## Product Change Notice (PCN)

PCN Number: **PCN-0451141R-01**

Product(s) Affected: PJ-035D

PREVIOUS CUI DEVICES DETAIL / IMAGE	NEW CUI DEVICES DETAIL / IMAGE

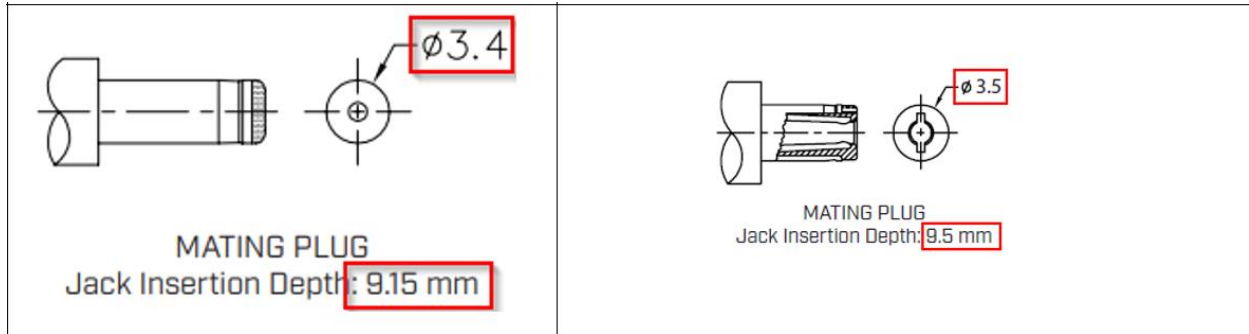
Description of Change: mechanical, and material differences as shown below:

MATERIAL	PLATING																																						
center pin	<b>copper</b>	nickel																																						
terminal 1	brass	tin																																						
terminal 2	<b>copper alloy</b>	tin																																						
terminal 3	brass	tin																																						
plastic	PBT																																							
DESCRIPTION	MATERIAL	PLATING/COLOR																																						
center pin	<b>brass</b>	nickel																																						
terminal 1	brass	tin																																						
terminal 2	<b>bronze</b>	tin																																						
terminal 3	brass	tin																																						
cover	PBT [UL94V-0]	black																																						
housing	PBT [UL94V-0]	black
